**Response to Submissions and Request for Information
Digital Advertising Signage – Pacific Highway, Hornsby (DA23/15294)**

This letter has been prepared by *Keylan Consulting Pty Ltd* (Keylan) on behalf of Sydney Trains (the Applicant) to address the Department of Planning, Housing and Infrastructure (DPHI) request for a Response to Submissions (RtS) dated 8 December 2023 and Request for Information dated 22 December 2023 in relation to the above development application (DA23/15294).

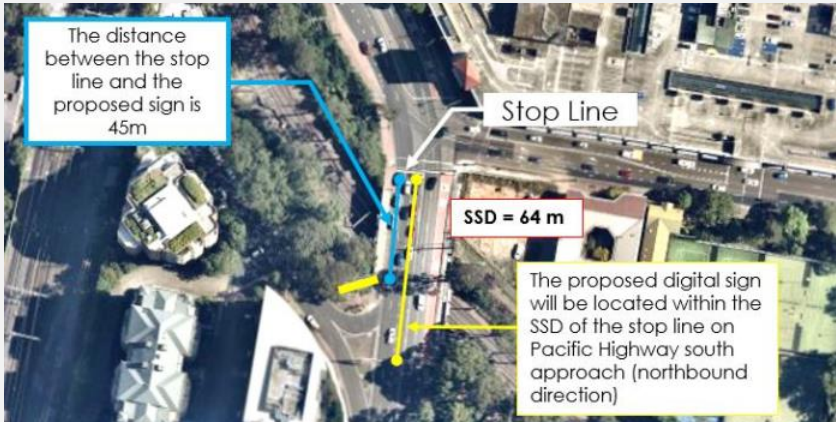
Ref.	Issues raised	Response
1	<p><i>I object to the application on the following grounds.</i></p> <p><i>Sydney Trains proposes to install a new LED digital sign at the location described -additional digital advertising at this site will be an additional distraction to motorists at a site that has heavy traffic, often changing lanes for the next part of their journey. There should be no further advertising distraction in this area.</i></p> <p><i>I do not think the public benefit of additional revenue is sufficient to outweigh the potential distraction and danger of the proposed digital sign.</i></p> <p><i>I also object to the additional lighting - the light spillage for those living on Pacific Highway, in the apartments next to and opposite the proposed sign.</i></p> <p><i>I dont think any of the benefits described are sufficient to make up for the increased distraction and danger for motorists or for the light spillage for those living nearby</i></p>	<p>Road safety</p> <p>The Digital Signage Safety Assessment (DSSA) prepared by The Transport Planning Partnership (Appendix C) considers the road safety impacts of the proposal.</p> <p>The DSSA acknowledges that existing signage is located within the vicinity of the proposed digital sign. Importantly, the existing signage has not resulted in any considerable road safety issues to date, evidenced by only one minor road incident recorded within the most recent crash data between 1/01/2017 – 31/12/2021.</p> <p>The SSDA concludes that the proposed sign and its location is an acceptable road safety outcome given the:</p> <ul style="list-style-type: none"> • proposed digital sign satisfactorily addresses the relevant standards and requirements. • proposed digital sign will not obstruct and/or reduce visibility of any traffic control devices, signage, road alignment or cyclists • proposed digital sign will not overlap/impact visibility of existing signage • minimal crash rate within the vicinity of the existing static sign and proposed digital sign <p>Importantly, we note that TfNSW have reviewed the proposal and have issued their General Terms of Approval.</p>

Ref.	Issues raised	Response
		<p>Public benefit</p> <p>As noted above, the DSSA supports the location and installation of the proposed digital advertising signage and TfNSW have issued their General Terms of Approval.</p> <p>Direct public benefits have been outlined in the SEE and the accompanying Public Benefit Statement. As stated within the Public Benefit Statement, the installation of this sign will provide a valuable revenue stream to Sydney Trains which will continued to be used to support a number of improvements and maintenance programs in accordance with the public benefit test provisions identified in the Industry and Employment SEPP and the Guidelines.</p> <p>Lighting impacts</p> <p>As noted, the proposed luminance is compliant with the <i>Transport Corridor Outdoor Advertising and Signage Guidelines</i> and relevant Australian Standards and therefore will not result in any unacceptable amenity impacts to nearby residents or accommodation.</p> <p>The Lighting Impact Assessment (LIA) accompanying the SEE has undertaken an assessment of the sign during the 'post-curfew' period (11pm to 6am), which is considered the most obtrusive nighttime period and generally when residents are trying to sleep.</p> <p>Lighting impacts on the nearest residential dwellings with potential views to the sign are assessed and the LIA concluded the sign demonstrates an acceptable level of compliance with the maximum nighttime illumination criteria specified.</p> <p>Furthermore, the brightness of the LEDs will be controlled to provide upper and lower thresholds as required, as well as automatically via a local light sensor to adjust to ambient lighting conditions. For example,</p>

Ref.	Issues raised	Response
		the LEDs will be dimmed during darker hours, typically during the night or overcast days.
2	<p><i>To whom it may concern,</i></p> <p><i>I am objecting to the sign as I believe that it will be more disruptive to the residents at 135 Pacific Highway Hornsby than made out in the DA. This will affect me, and other apartments on that corner of government road being right on the corner and at a level that will have clear view of a constantly changing sign with bright colours. The DA says that it is "anticipated" to only effect the first two residential levels. Being on the third level, I find that it will also significantly effect my family also.</i></p> <p><i>* The building is listed as Mixed Use however, only a tiny proportion of the building is retail and the majority is residential.</i></p> <p><i>* Although it is quoted to be significantly smaller, the current billboard is static. The output of light is a constant and reflective rather than an emitting light that is changing up to 4 times a minute 24 hours a day.</i></p> <p><i>* Even if the view is not "Generally" front on as quoted, this emitting bright light will cause a high visual impact.</i></p> <p><i>* The constantly changing sign during sleeping hours will cause light pollution into bedrooms that are facing the sign directly. A static reflected light does not have that same impact as a bright light that is changing colours.</i></p> <p><i>We would like to beg the planning department to consider the residents that will have to endure this constantly changing sign. At the very least to limit its use during daylight hours only.</i></p> <p><i>Sincerely,</i></p>	<p>The LIA and Visual Impact Assessment (VIA) submitted as part of the DA assessed lighting and visual impacts on the residential dwelling at 135-137 Pacific Highway, Hornsby.</p> <p>Lighting impacts</p> <ul style="list-style-type: none"> As stated above, the LIA assessed the proposed signage against AS 4282-2019 <i>Control of the Obtrusive Effects of Outdoor Lighting</i>. Noting the digital signage will operate 24 hours a day, the LIA assessed the proposal against stringent post curfew limits to account for light spill between 11pm – 6am (AS4282 post curfew times) when residents are sleeping. It is concluded that the proposed development complies with the relevant standards. In complying with this criteria, it is determined that the sign will not result in unacceptable glare or adversely impact the safety of pedestrians, residents or vehicular traffic and will not unreasonably impact the visual amenity of nearby residences. <p>Visual impacts</p> <p>The VIA concludes the sign will not have unacceptable visual impacts for the following reasons:</p> <ul style="list-style-type: none"> Impacts on the amenity of lower-level dwellings are mitigated by the existing dense landscaping on the eastern side of the building façade which partially screens the sign from balconies and windows. The sign is orientated south towards Pacific Highway. Meaning residential dwellings generally will not have a direct view of the illuminated side of the sign.
